DART AEROSPACE LTD	Work Order:	159199
Description: Crosstube Assembly, Mid Fwd	Part Number:	D206-667-147
Inspection Dwg: D206-667-147 Rev: A		Page 1 of 2

DART AEROSPACE LTD HAWKESBURY, ONTARIO, CANADA	
DRAWING NO. D206-667-147	REV. A SHEET 1 OF 4
TITLE CROSSTUBE ASSY (206L MID FWD)	SCALE NTS

DRAWING NO. D206-667-147	TITLE CROSSTUBE ASS'Y (206L MID FWD)	REV. A	DART AEROSPACE LTD ENGINEERING ORDER		D.E.O. NO. D206-667-147-A-1	SHEET NO. SHEET 1 OF 1	SCALE NTS
DRAWN 92	CHECKED ASS		MFG. APPR. [Signature]	APPROVED [Signature]		DE APPR. [Signature]	
DATE 11.07.15	DATE 11.07.20		DATE 11.07.21	DATE 11/07/21		DATE 11.07.21

DRAWING NO. D206-667-147	TITLE CROSSTUBE ASS'Y (206L MID FWD)	REV. A	DART AEROSPACE LTD ENGINEERING ORDER	D.E.O. NO. D206-667-147-A-2	SHEET NO. SHEET 1 OF 1	SCALE NTS
DRAWN AJS	CHECKED	MFG. APPR. <i>E</i>	APPROVED <i>AP</i>	DE APPR. <i>AP</i>		
DATE 12.08.02	DATE 12.08.02	DATE 12.08.02	DATE 12.08.02	DATE 12.08.02	DATE 12.08.02

DETAIL P
BONDING STRAP INSTALLATION 2 PL

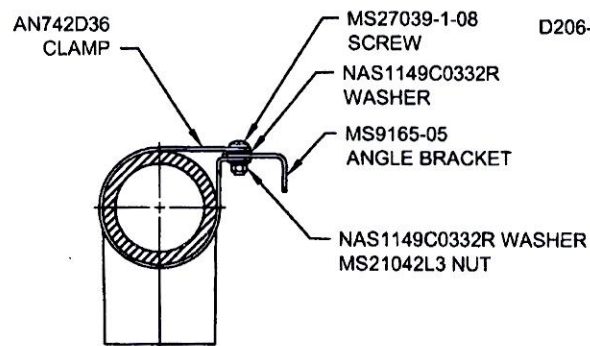
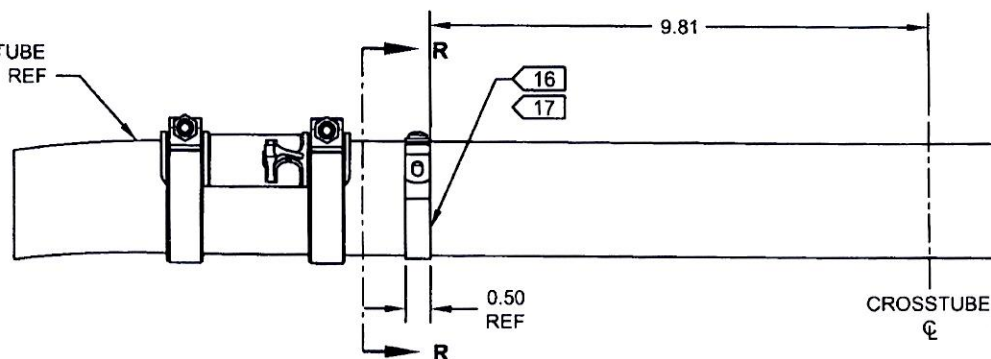
PURPOSE:

ADD ELECTRICAL GROUNDING STRAP

ITEM	QTY -147	PART NUMBER	DESCRIPTION	
1	X	D206-667-147	CROSSTUBE ASSEMBLY (206L MID FWD)	
10	2	AN742D36	CLAMP	} ADD
11	2	MS9165-05	ANGLE BRACKET	
12	2	MS21042L3	NUT (OR MS21042-3)	
13	2	MS27039-1-08	SCREW	
14	4	NAS1149C0332R	WASHER (OR AN960C10L)

- 16) MASK AREA UNDER CLAMP PRIOR TO PAINTING
 17) SEAL EDGES WHERE AN742D36 CLAMP MEETS WITH THE CROSSTUBE USING SIKAFLEX-241/-291 OR MIL-S-8802 CLASS B2 OR PROSEAL 890 SEALANT
 18) PERFORM RESISTANCE CHECK TO ENSURE MAX RESISTANCE IS 10 MILLIOHMS
